Appendix 8: Three Waters Peer Review

DRAFT TECHNICAL SPECIALIST REPORT THREE WATERS PROPOSED WAIKATO DISTRICT PLAN REZONING REQUESTS - OHINEWAI

PREPARED FOR WAIKATO DISTRICT COUNCIL

February 2020

Figure 2-6: Model Results for Lower Boundary Condition Level 2-year ARI (from OFA Report)

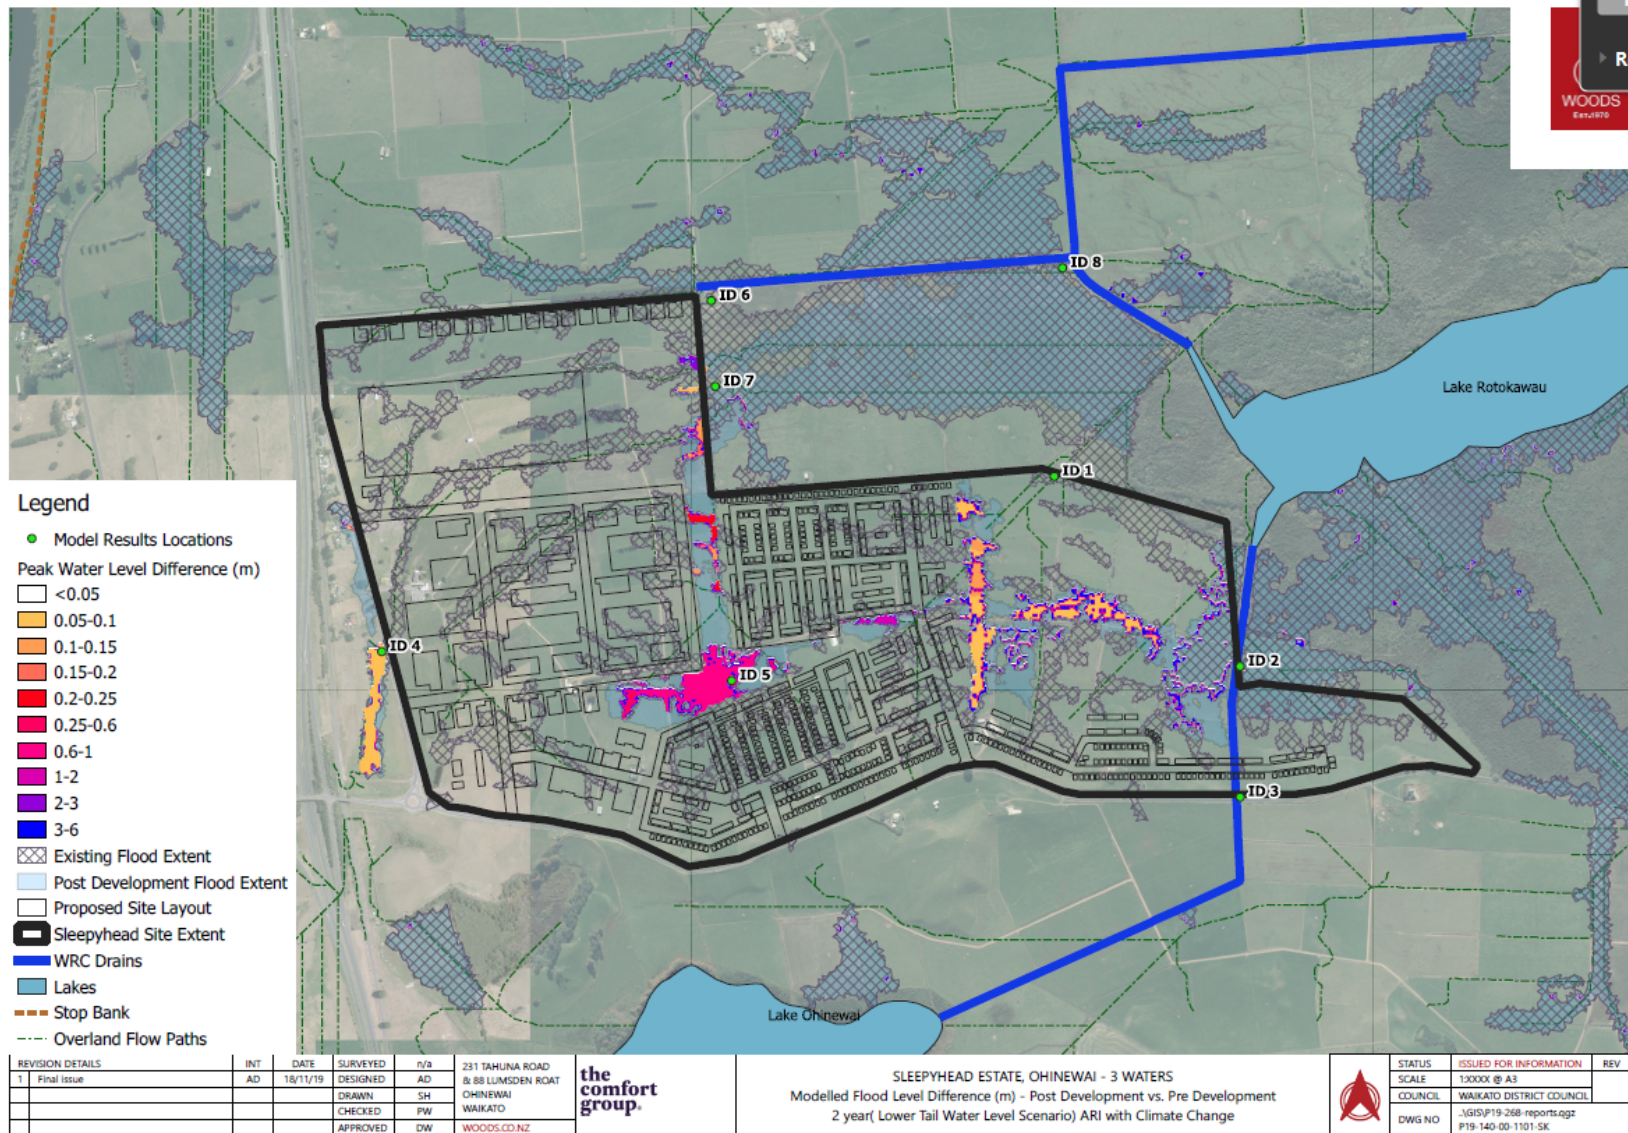
- In the lower tailwater level scenario - the OFA Report noted a decrease in depth at Sites 6 and 8 and complete removal of flooding at Site 1 and 7 in the post-development scenario. Stantec requested clarity on how this has been achieved. Woods have responded that the reduced flows at Sites 1, 6, 7 and 8 are due to flows being diverted away from Balemi Drain, down through the Central Park area and towards the wetland, as agreed by WRC. Flows through Tahuna Drain have been passed forward within the model so the model will not show any capacity issues. Design requirements for Tahuna Drain are discussed in Section 2.3.6.2.

- Changes to flow paths directions across the development lead to changing flow depths at Sites 4 (Lumsden Road drain), 5, 6, 7 and 8 (Balemi Drain)
- Where there was no local land modification (Site 2) the flood levels were maintained

- While increase impervious area leads to changes in runoff from the development, the peak flows from the development occur before the main peak of the storm. Therefore, while the results show no impact from the development on the flood plain level, it could impact on the rising limb of the storm flows leading to longer periods of inundations within the site.

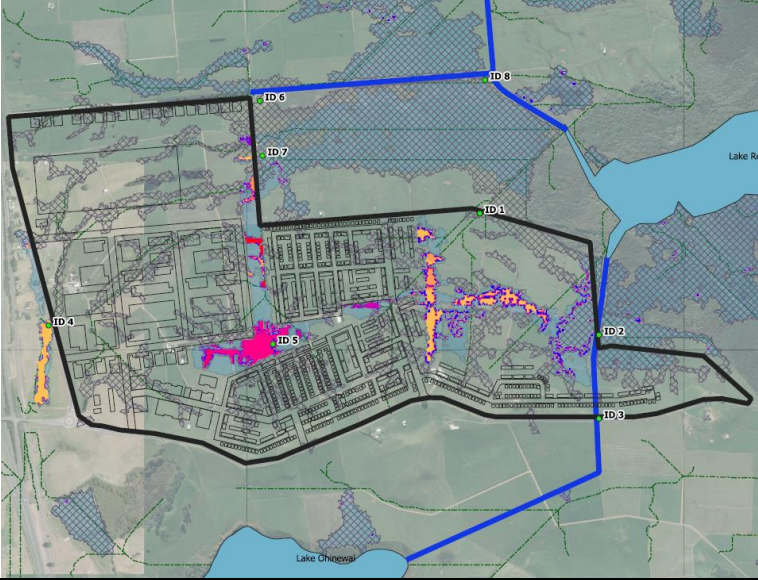
<p>Reference figure</p>
02	<p>The OFA Report noted an increased ponding at the culvert (Site 4) between pre and post development scenarios. Clarity over the cause of the increase in depth is required to understand if the development is impacting on the levels, because of climate change, or other factors</p>	<p>For pre and post development model runs include climate change uplift.</p> <p>The overland flow path located around Lumsden Road at location 4 exhibits ponding behind Lumsden Road for pre and post development scenarios. This is caused by the model representation in this area which does not include the culvert under the existing road. This results in ‘no flows’ through the culvert and flows backing upstream with no downstream conveyance. This culvert under Lumsden Road will be addressed at detail design stage and designed to maintain the predevelopment flood levels.</p>
03	<p>The post development maps in Appendix E of the OFA Report show no flooding in and around the buildings with significant earthworks required. Will the stormwater management devices on site address both flood displacement volume and attenuation volume from the increase in impervious area? This was stated in the Memo to Mercury Energy in Appendix C.</p>	<p>Displacement volume/ flood storage lost based on flood levels of 5.4mRL as well as 8.0mRL are less than 0.5% when compared to the total storage available within Lake Waikare.</p> <p>Modelling undertaken indicates that flows from this development can be passed forward without impacting on predicted flood levels at Lake Waikare / Lake Rotokawau.</p>

<p>The general approach is to pass flows forward from the proposed development (1.79 sq. km) before the upstream flows reach Lake Waikare (206 sq. km). Holding flows back could result in coinciding of peak of the storm resulting in higher risk to the proposed development as well as neighbouring properties. The time of concentration for the flows from the site is < 10 minutes whereas that for upstream catchments discharging to Lake Waikare is > 3 hrs (calculated using SCS Unit Hydrograph method, as specified in the Waikato Stormwater runoff modelling guidance (TR2018/02)). Refer to Figure 1 below.</p> <p>Hence the stormwater management devices would primarily serve the purpose of treatment with some attenuation benefits.</p>
04	<p>The OFA Report noted a decrease in depth at Sites 6 and 8 and complete removal of flooding at Site 1 and 7 in the post-development scenario. How has this been achieved at each site? Further explanation is needed. For example flow diversion? Can this be sketch up on a plan view?</p>	<p>Refer Figure 2 below shows the approximate discharge locations for the proposed development discharges.</p> <p>The existing terrain slopes down towards Lake Rotokawau/ Lake Waikare with low lying areas to the north-east of the proposed site. The locations shown in the figure and tabulated with water levels highlight the differences in overland flow paths for the pre and post development scenarios which now discharge to the Business Park area where they are either held back (where we see a localised increase within the site) or discharge overland to Lake Rotokawau. Primary reason for decreases at locations 6,7 and 8 are based on the fact that there are no discharges to the Land Drainage scheme (which in agreement with WRC).</p>

Figure 1: Peak time analysis

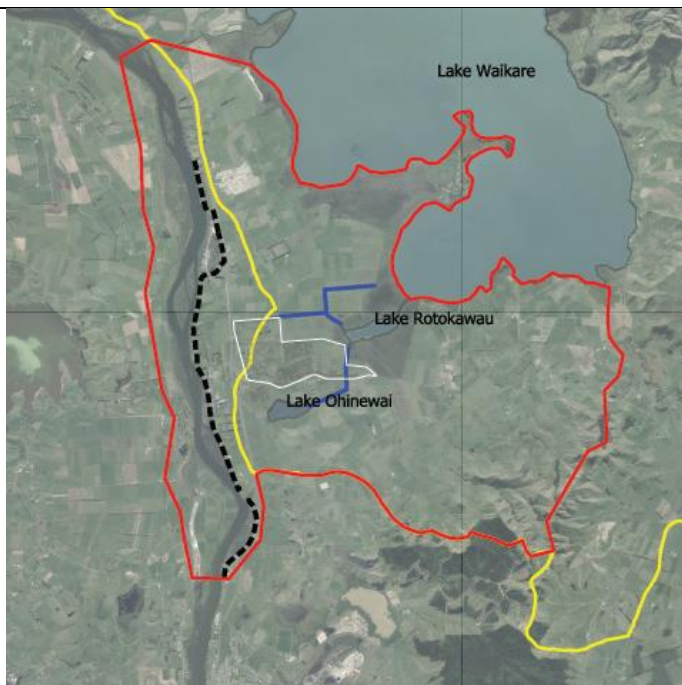
<p>Waikare with loss of storage by fill in development area assuming the Lake Waikare gate is closed, i.e. no flows discharging downstream to Lake Whangamarino:</p> <ul style="list-style-type: none"> - At 5.4mRL the increase in water level is ~0.006mm - At 6.3mRL the increase in water level is ~1.026mm - At 8.0mRL the increase in water level is ~13.03mm
08	How are the culverts modelled, do they pass forward flows? Sized to take the storm events. Confirm if the model identifies flooding around culverts or if that will be completed at a later stage.	<p>All culverts are assumed to be designed based on the approach of pass forward and not included in the models.</p> <p>Only flooding observed around culverts is noted around Lumsden Road at location 4 exhibits ponding behind Lumsden Road for pre and post development scenarios. This is caused by the model representation in this area which does not include the culvert under the existing road. This results in 'no flows' through the culvert and flows backing upstream with no downstream conveyance. This culvert under Lumsden Road will be addressed at detail design stage and designed to maintain the predevelopment flood levels.</p> <p>There are no discharges proposed to Tahuna Drain will be designed to convey all upstream flows possibly as a culvert which has been discussed with WRC.</p>

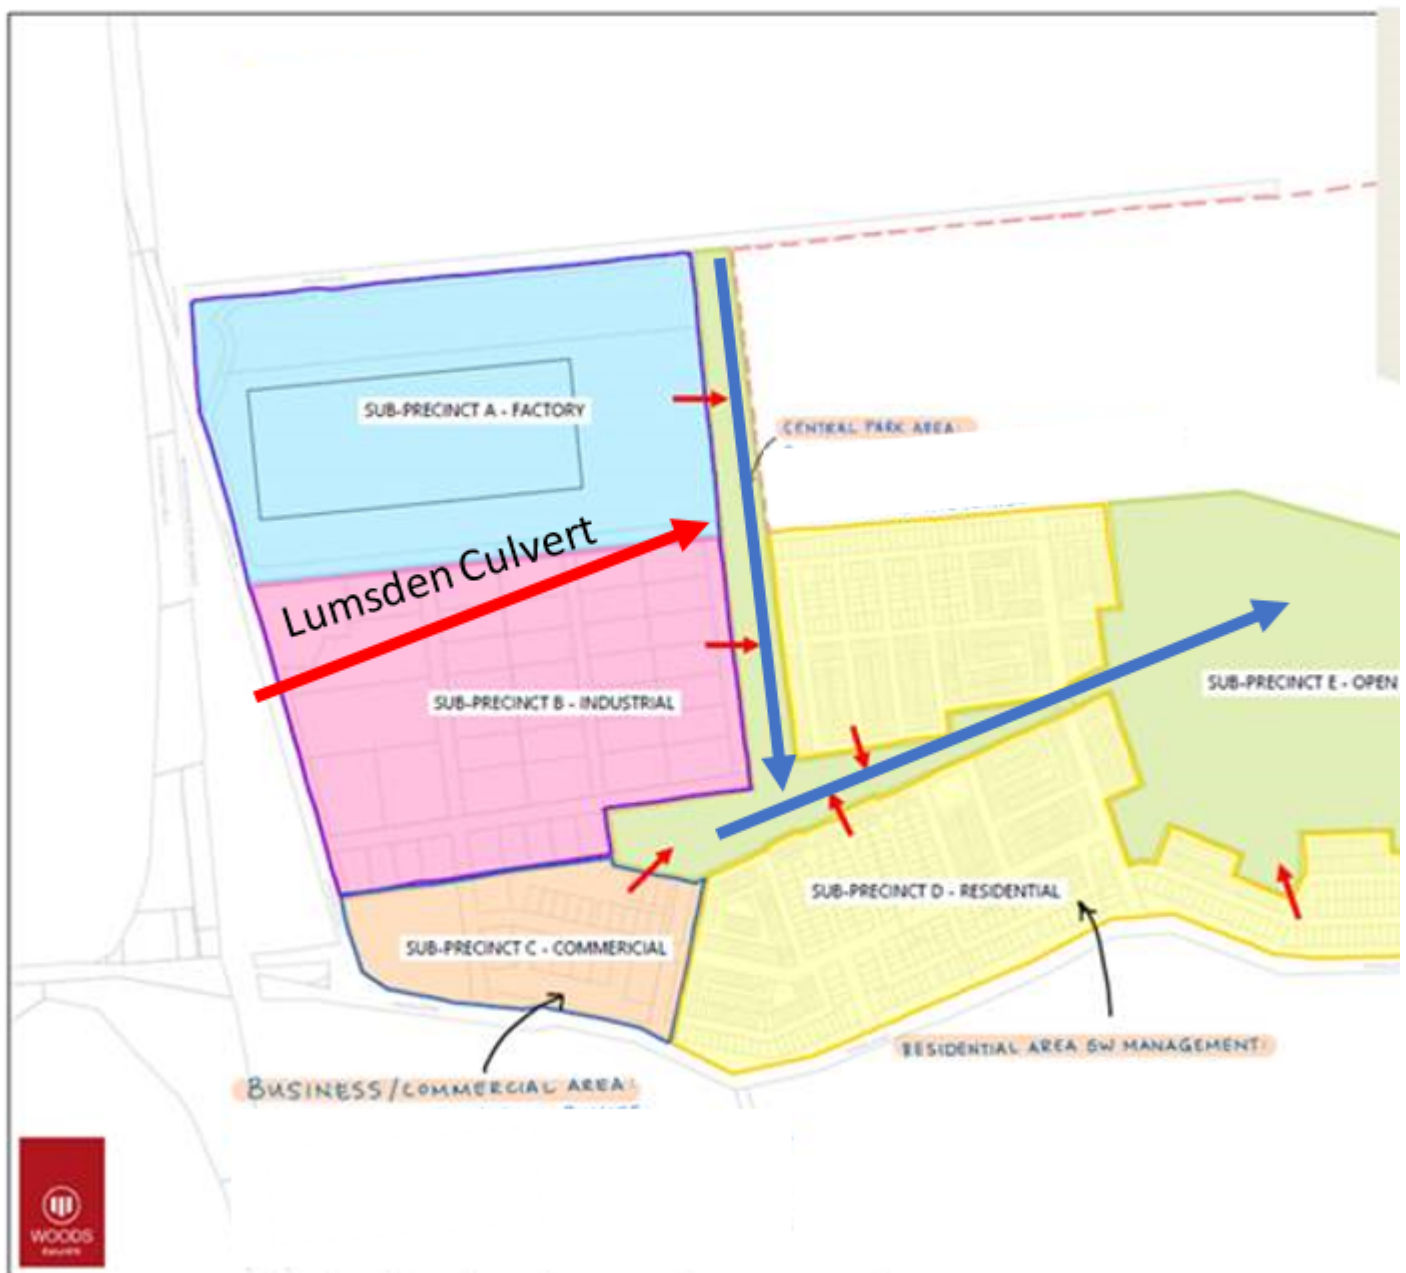
Please confirm if the image below is correct in terms of flow paths. As I will add it to the report.
